Barry Township
T 1 N R 9 W
Barry County
Michigan

Section 7
08-03-007-
Scale 1"= 400'

This tax map was compiled for tax administration purposes from county and township records. It does not represent a land survey. Barry County Land Information Services 220 West State Street, Hastings MI 49058 (269) 945-1292 or <http://www.barrycounty.org/>

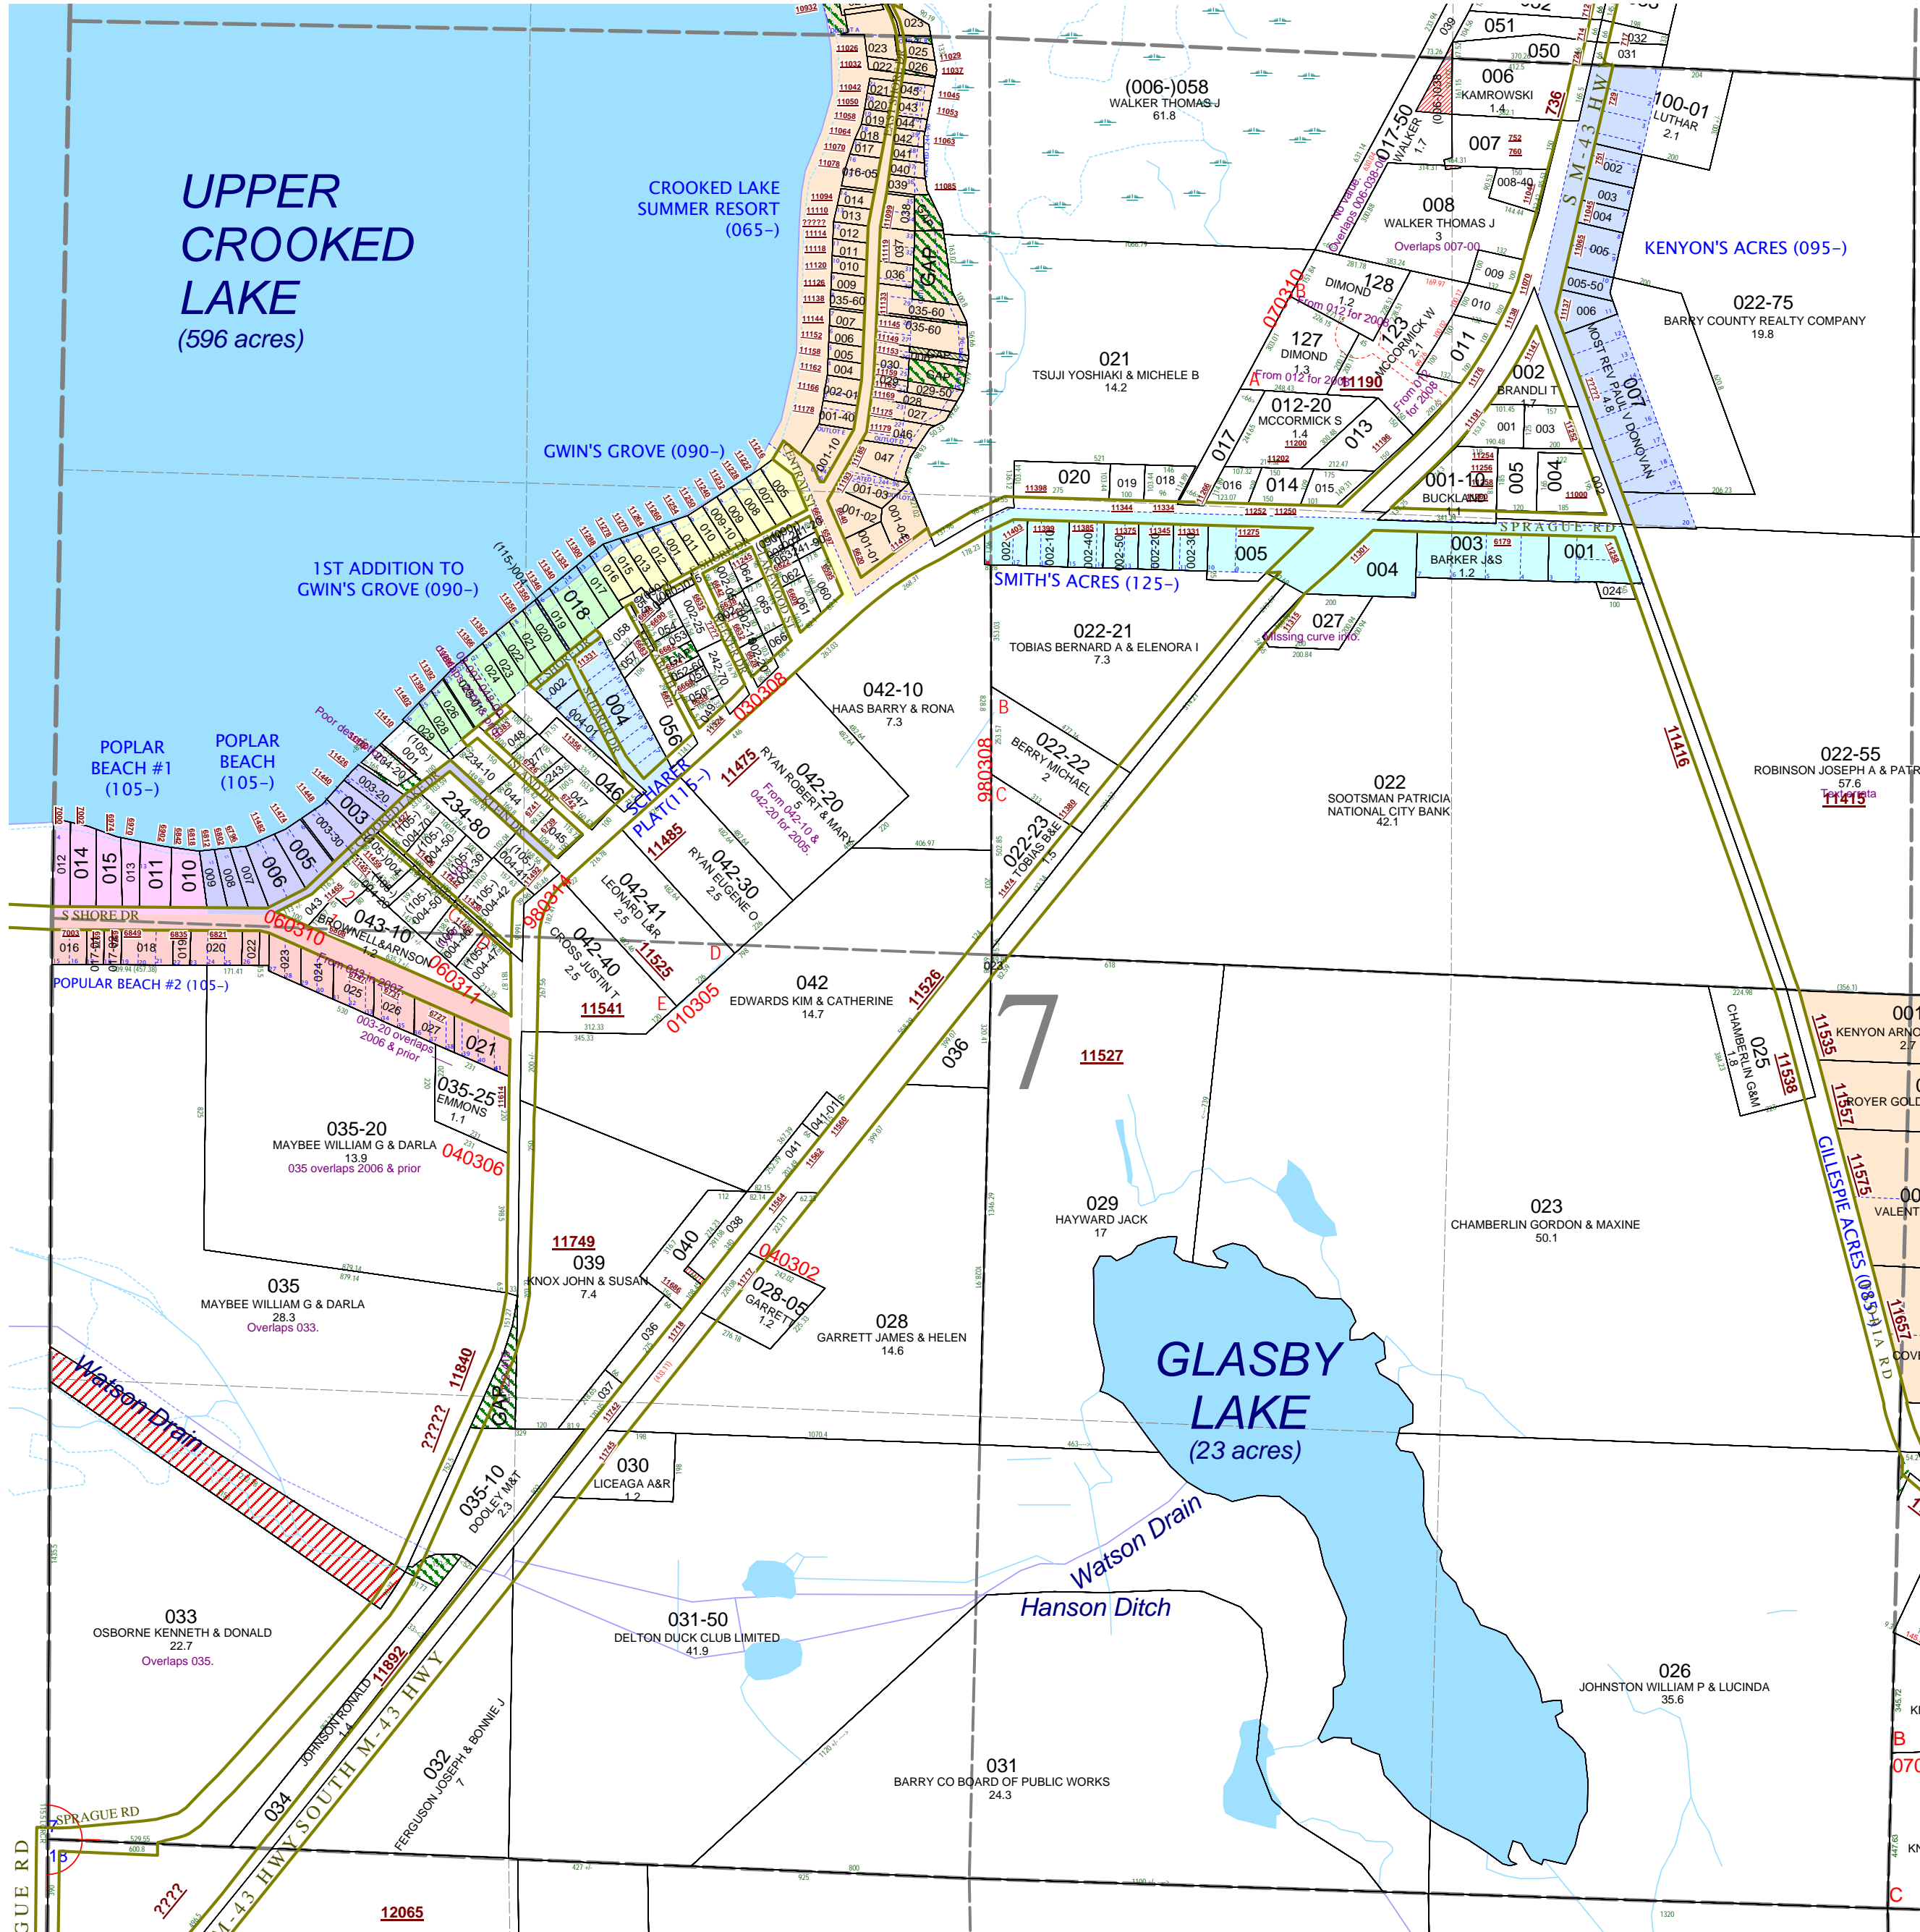
08-03-065-023-00 needs to include lake front parcel (not on R#1008351).

GAP in outlet B owned by the Estate of Mary Baker, Raymond H. Baker heir designate in L.152-121.

GAP in outlet C owned by Cornelius J. VerCies in L.188-557.

GAP in outlet C owned by Melvin Raab in L.640-877.

08-03-065-006-00 needs to include gap to the east because it didn't get it all the parcels from the combination made in 2005.

08-06-065-030-00 needs to include gap parcel to its east. See R#1165062.

08-03-007-052-60 needs to include gap parcel to the northwest.

08-03-007-234-20 has a poor point of beginning. I think they assumed the south corner of Gwin's Grove was on the southerly point of the old road way rather than on the south corner of the lot.

08-03-105-007-00 has the plat name misspelled, it should be "POPLAR" not Popular.

08-03-105-008-00 has the plat name misspelled, it should be "POPLAR" not Popular.

08-03-105-004-50 has a small typo, change "TH 49D 1M 29S E 79.58 FT" to "TH S49°01'29"E 79.58FT".

GAP deeded from Nellie Hayward to Dorothy Welch in L.222-415 and NOT deeded onto Charles O'Grady in L.327-14. Mr. Knox on 039-00 is working on acquiring this property.

08-03-007-035-00 overlaps 033-00. Both parcels are claiming swamp and refer to a point 1320 feet north of 1/4 post on west line of section 7, but one refers to the Prairieville post, the other to the Barry post and there is a 215.5 foot difference.

08-03-006-038-00 overlaps 03-007-017-50 and is in two pieces in two separate sections.

08-03-007-007-00 second description does not close. See R#1104188 for parcel #4.

08-03-007-017-50 needs to exclude part retained by McCormick on sale to Langerveld parcel #5 of R#1104188 and include triangle piece from parcel #4 and exclude parcel underneath shed.

08-03-007-008-40 needs to include curve data.

08-03-007-008-00 needs to exclude parcel not sold on to Langerveld/Walker on land contract underneath the shed.

08-03-007-027-00 is missing the word "radius" after the curve information.

08-03-007-022-55 has stray text at the end of the description.
